## **NRC Request**

1. *Entergy Nuclear Operations, Inc. (the licensee) stated in its submittal dated June 30, 2009, that the break selection process was re-performed after fibrous debris zones of influence (ZOI) were reduced. However, the licensee further stated that after a significantly large fiberglass component was identified, deference was given to evaluating breaks for other debris sources. The Nuclear Regulatory Commission (NRC) staff cannot determine from this information whether the break selection was conservative. Please verify and justify that the break selection process identified the break that results in the maximum potential fibrous debris load and that this debris load was considered in the remaining portions of the head loss evaluation.*

**Entergy Nuclear Operations Response, RAI's 2-9:**

**Figure 10.1: Cal-Sil Sample Before Erosion Testing**

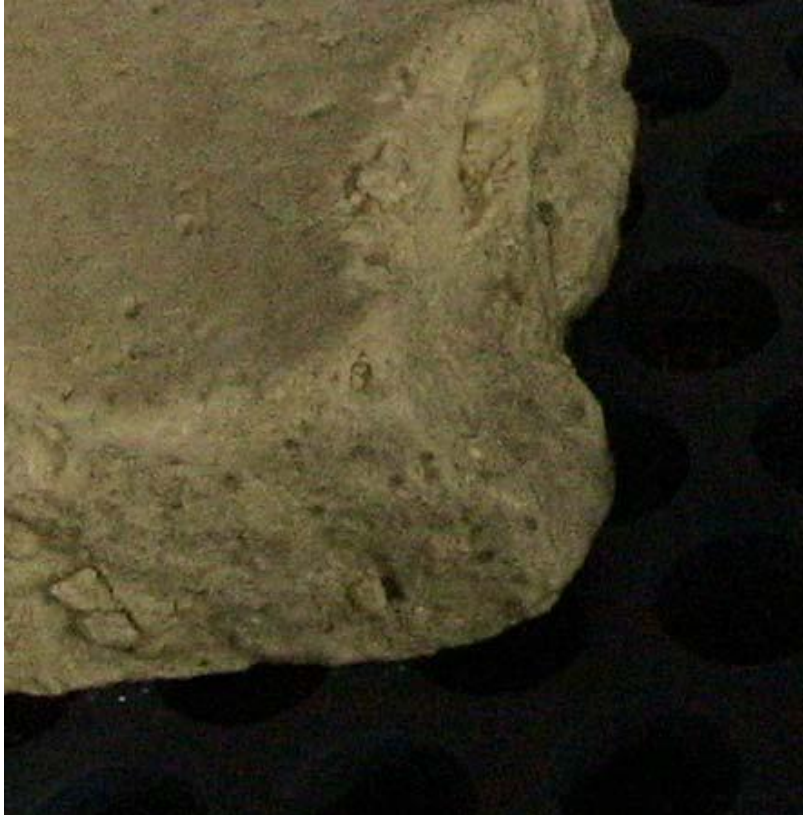
- Please provide the basis for concluding that pieces of Marinite debris will not transport to the strainers or erode in the post-LOCA containment pool. Although Section 4.2.2.2.5 of NEI 04-07 states that Marinite can be assumed to be broken into large chunks, the staff could not determine that NEI 04-07 or the accompanying safety evaluation provides a basis for concluding that this Marinite is not susceptible to transport or erosion. The staff has seen results from testing demonstrating that Marinite does erode when submerged and exposed to flow.

Erosion testing of Marinite showed that when exposed to flow velocity of 0.4 ft/s for 32 hours, the Marinite samples experienced a maximum weight loss of 1.22% [Ref. 10.5]. However, this quantity was determined to be primarily the wearing away of the rough edges initially found on the broken Marinite sample pieces. This erosion pattern was very similar to that observed on Cal-Sil samples tested concurrently with the Marinite. Images of the Cal-Sil before and after erosion testing are shown in Figure 10.1 and Figure 10.2, respectively.

Thus, although there was a 1.22% erosion of sample weight over 32 hours, it is expected by the erosion pattern that this would represent the majority of the erosion of the sample expected to take place over the 30 day mission time.

**Figure 14.5 - OPG 13D Test Target Post-Destruction (Rear View)  
(Figure D11 in Ref. 5)**

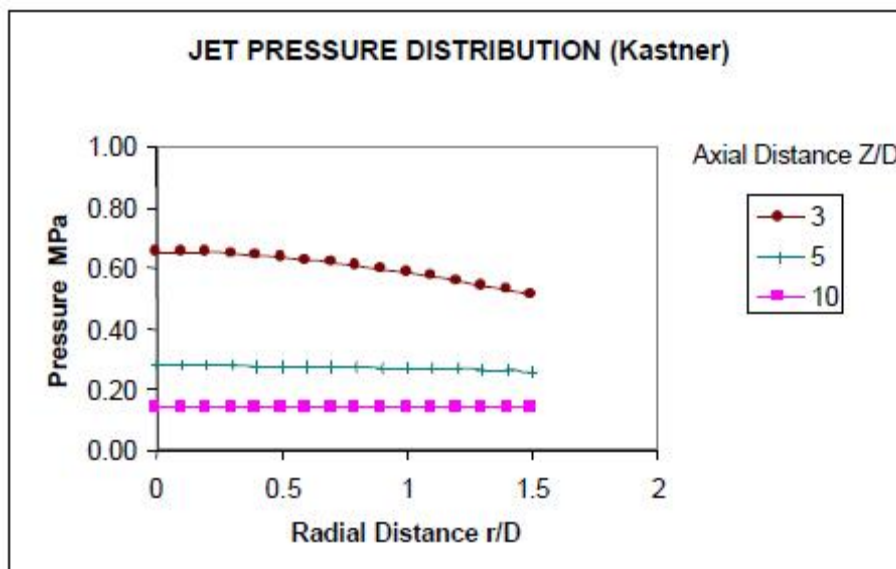
14. *The June 30, 2009, supplemental response appeared to indicate that only 50% of the calcium silicate within a 5.45D ZOI was assumed to be destroyed into small fines. The other 50% of the calcium silicate within this ZOI was assumed to remain intact following the impact of the LOCA jet. The assumed size distribution appeared to be based on OPG testing for which less than 50% of the target calcium silicate was damaged by jet impingement. Please address the following items concerning the assumed calcium silicate debris distribution:*

Based on the photographic evidence from the OPG tests used in determining the size distribution of destroyed Cal-Sil debris (5D, 7D, 9D, 11D, 13D, and 20D tests presented in Figures 14.1 through 14.6) it is apparent that most significant destruction of the target insulation was not directly in front of the jet nozzle but was instead located almost randomly along the length of the target [Ref. 5]. The 9D and 7D tests (OPG tests 8 and 12) show a very uniform destruction pattern along nearly the entire length of the target, with the far side of the target insulation removed and the nearside remaining intact under intact jacketing. The 13D and 20D tests (OPG tests 14 and 15) show a destruction pattern centered at one end of the target, with the centerline of the target directly in front of the nozzle relatively intact.

Figure 3. Immediate area of A-Loop SG compartment [Ref. 15.1]

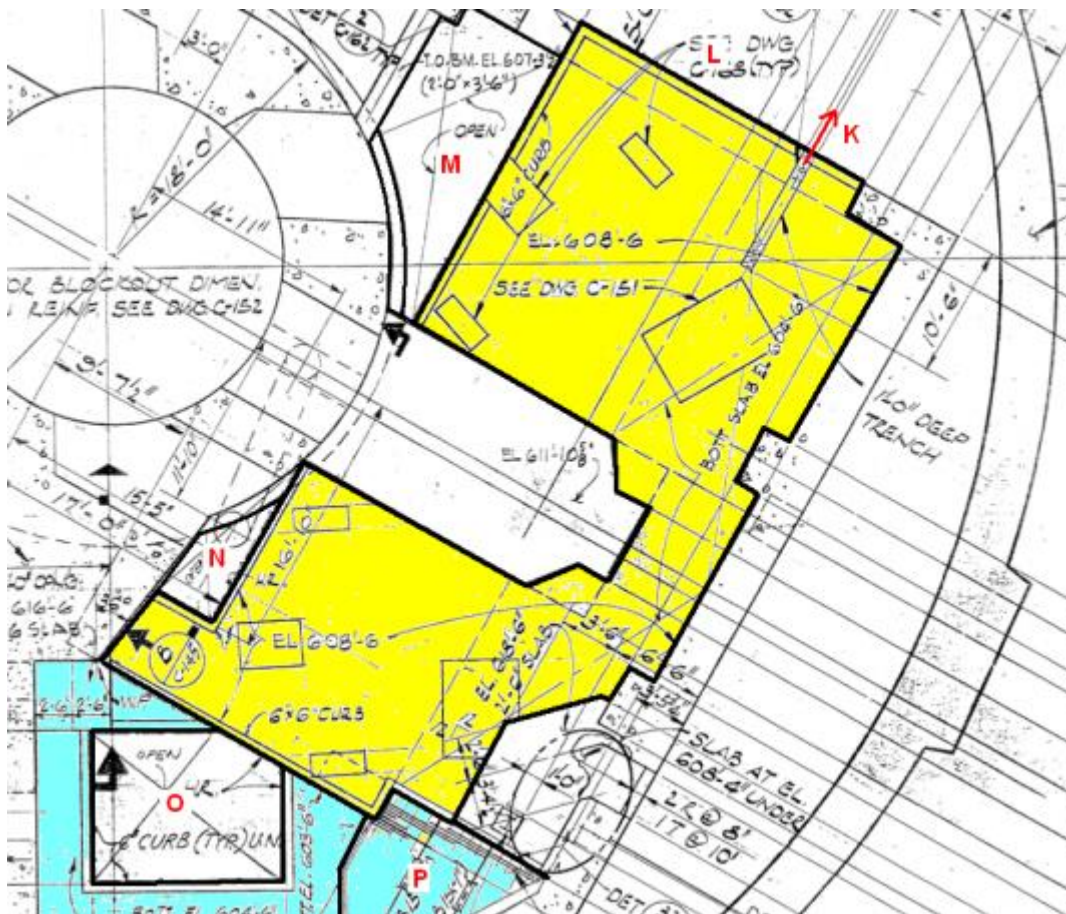
15. *The licensee's June 30, 2009, supplemental response stated that large pieces of debris were assumed to be retained on the 608'6" elevation (EL) rather than transporting to the 590' EL. The licensee's response added that it was ultimately inconsequential whether the large pieces were retained on the 608'6" EL or washed down to the 590' EL, since direct transport to the strainer would not occur in either case, and an equivalent degree of erosion would occur regardless of the elevation on which the debris was assumed to settle. It was not clear to the NRC staff that it was inconsequential whether large pieces remained on the 608'6" EL or transported to and settled on the 590' EL. In particular, the NRC staff expected that the flow conditions (e.g., velocity and turbulence) on these two elevations could be significantly different, thereby leading to different percentages of eroded debris. In particular, the NRC staff expected that erosion would be more severe on the 608'6" EL because (1) shallow pools exist, (2) there is significant potential for break and/or spray drainage to create high-velocity and high-turbulence flow conditions, and (3) the potential exists for direct exposure to break and/or spray drainage flows. It is not clear to the NRC staff that flow conditions of this sort are bounded by industry erosion testing conducted with significant submergence, no direct exposure to drainage flow, and relatively low velocity and turbulence values, and how this potential discrepancy has been addressed in the licensee's strainer performance evaluation. Therefore, please identify the range of water velocity and turbulence levels expected on the 608'6" EL, the expected water depth, as well as the basis for concluding that an equivalent degree of erosion would occur for debris retained on the 608'6" EL as would occur on the 590' EL considering the industry erosion test conditions and results. As applicable, please also provide similar discussion for any other locations where significant debris holdup was credited for which erosion may occur under similar conditions to that applicable to the 608'6" EL (e.g., the stairwells leading from the 608'6" EL to the 590' EL).*

For Palisades containment the limiting break from a debris generation and also a debris transport perspective occurs in the A-loop. The A loop geometry is shown in Figure 3 with run-off paths identified by letter code. Overall, 83 ft of 6" high curbing surround the area marked in yellow. Only one trench-like opening exists in the curbing. This run-off path is marked K. Approximately half of the area is protected from direct spray from above by the steam generator and other concrete closures in the upper elevations of containment. Given the spray and break-flow inputs that exist during an A-loop break, the floor of the area marked in yellow will flood to over-flow the curbing. To support the run-off of water, the water level will rise to 7". Given the length of the curbing, an approach velocity to the curb of 0.09 ft/sec can be calculated. This velocity is insufficient to allow the larges to transport out of the curbed area since the lift-over-curb velocity for larges is 0.34 ft/sec [Ref. 15.2 and 15.3]. While the areas of direct break flow

impact may be subjected to high velocities it is expected that a) the duration of exposure of a large amount of insulation to such high velocities is very short as the insulation is pushed away by sheeting water after the initial blast and blow-down b) the amount of insulation exposed to high velocities for an extended period of time is very small. Even though a large amount of debris will be pushed to areas where break flow no longer provides significant velocity and spray flow does not exist (half of the area is covered by concrete slab or protected by the upper geometry of the steam generator) large debris is eroded to fines at a value of 10%. Furthermore, note that the velocities approaching the curb will drop off dramatically to the point where larges will stop transporting and not block the curbing.

Figure 16.4. View of SG-A compartment near pressurizer

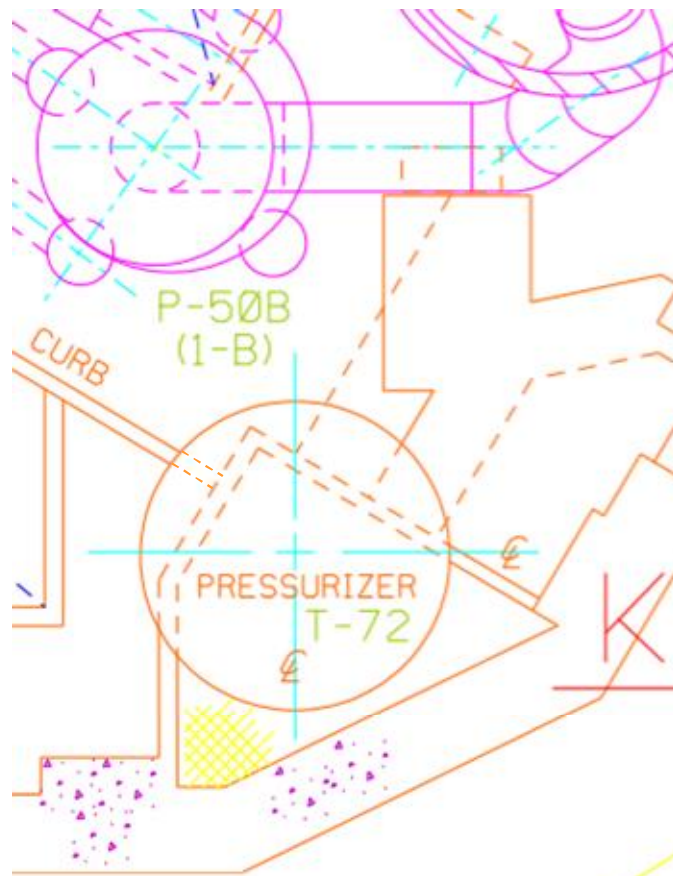
16. *Although the licensee's June 30, 2009, supplemental response quoted a statement in NUREG/CR-2982 indicating that mineral wool can remain afloat for extended periods of time, it did not appear that the licensee had accounted for the potential for floatation adequately in the following two respects:*

*Please provide additional information to justify the assumption regarding flotation of mineral wool, considering the above.*

- While it is possible that some very small fraction of mineral wool smalls from the pressurizer could end up on the main steam generator floor, this debris will mix with Nukon fiber debris.
- Small mineral wool debris that remains afloat in the main steam generator compartment could flow over the existing curb and down into the containment pool. The test basis was developed by neglecting this possible transport (floating), instead eroding all mineral wool debris, including the vast majority which is not subject to spray flow or other transport mechanisms.

Based on the above discussion debris transport of mineral wool larges by floatation is not credible and only possible for small fractions of mineral wool smalls. Although the bulk of the mineral wool debris will be located on largely dry grating, all mineral wool debris smalls and larges were eroded at 10% to fines leading to a very conservative testing basis for mineral wool debris.

Figure 17.1 – Containment Erosion Zones

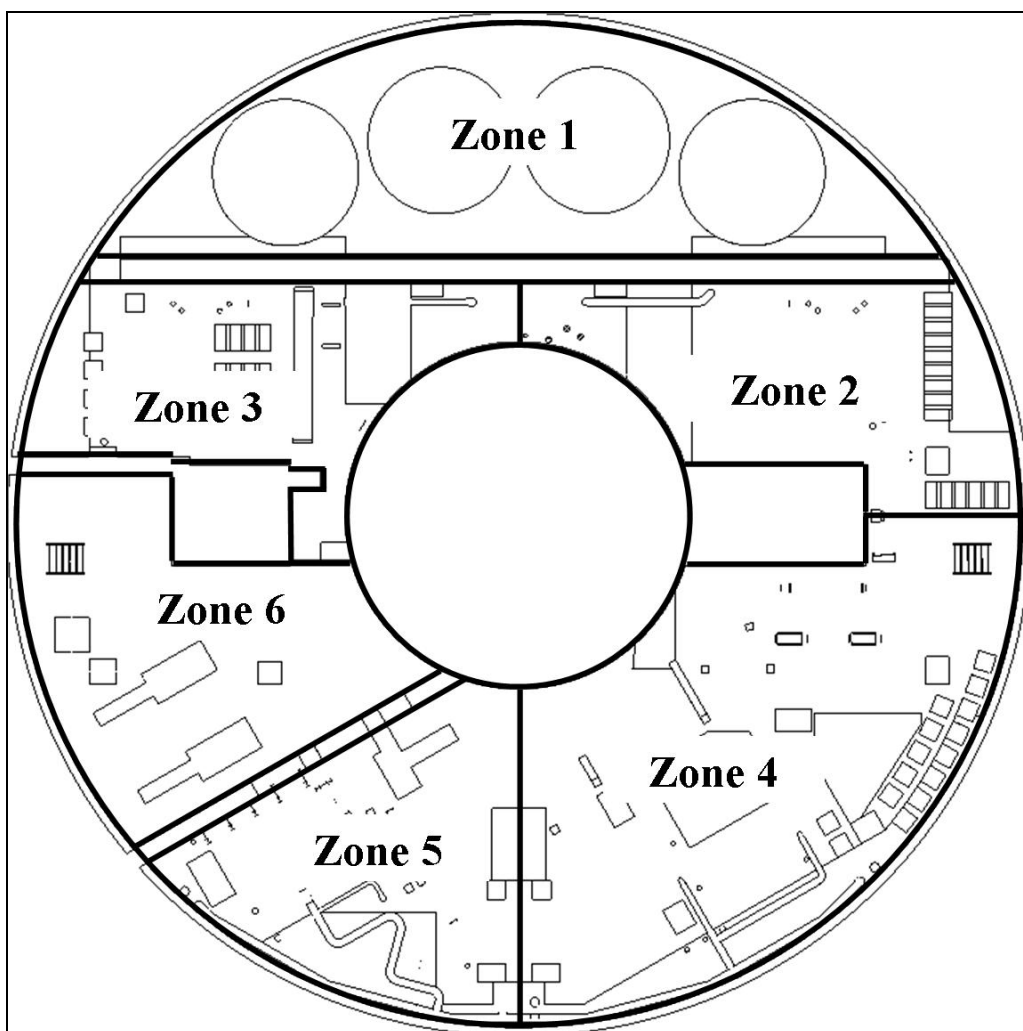
- a. *Please describe the test facility used for any erosion testing and demonstrate the similarity of the flow conditions (velocity and turbulence), chemical conditions, and fibrous material present in the erosion tests to the analogous conditions applicable to the plant locations where erosion could occur.*

**LDFG – Flow Velocity and Kinetic Energy:** After the bulk transport of the debris, a total of 64.2% of the small fiberglass debris generated would be on the containment pool floor where it could be exposed to erosion. The average flow velocity and turbulent kinetic energy (TKE) was calculated in six different zones within the containment [Ref. 14]
